The recommended improvements for the I-70 and US 35 interchange in Richmond have been updated.

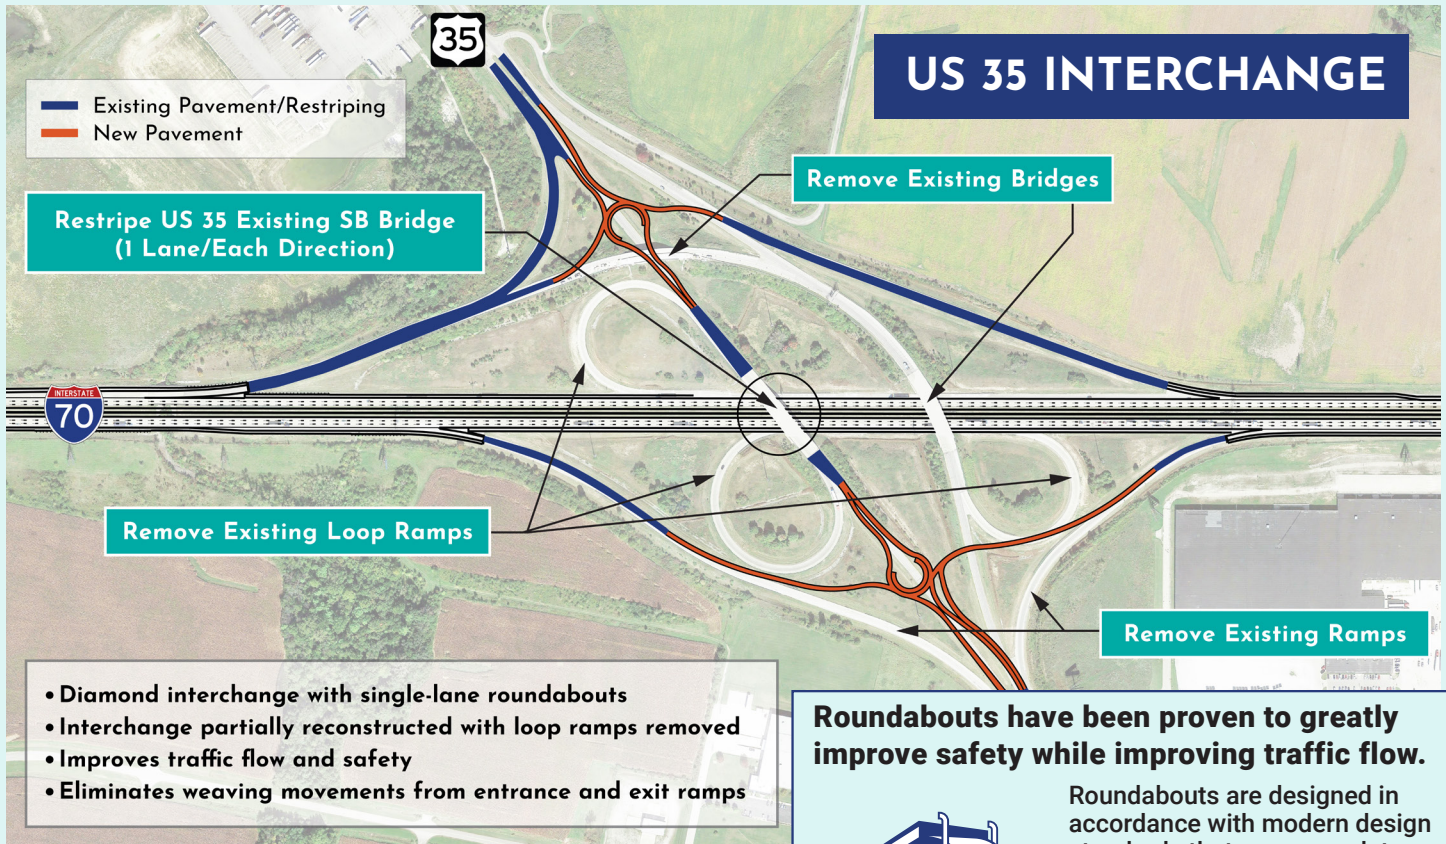
Initial Recommendations: Partial modifications to the interchange were recommended to improve the acceleration and deceleration length of each ramp movement.

Updated Recommendations: The modification at the US 35 interchange includes more robust improvements with a tight diamond interchange and two single-lane roundabouts to improve traffic flow and safety in the area. Existing loop ramps will be removed.

Impacts are reduced with the updated design.

Right-of-Way	Reduced to 0.06 acre for the entire project.
Streams	There is no change in the impact.
Wetlands	There is no change in the impact.
Terrestrial Habitat	Decreased to 230.98 acres due to reduction in right of way.
Protected Species	IPAC determination will be updated.
Farmland	Reduced to no impact.
Noise	No change.
Permits	No change.
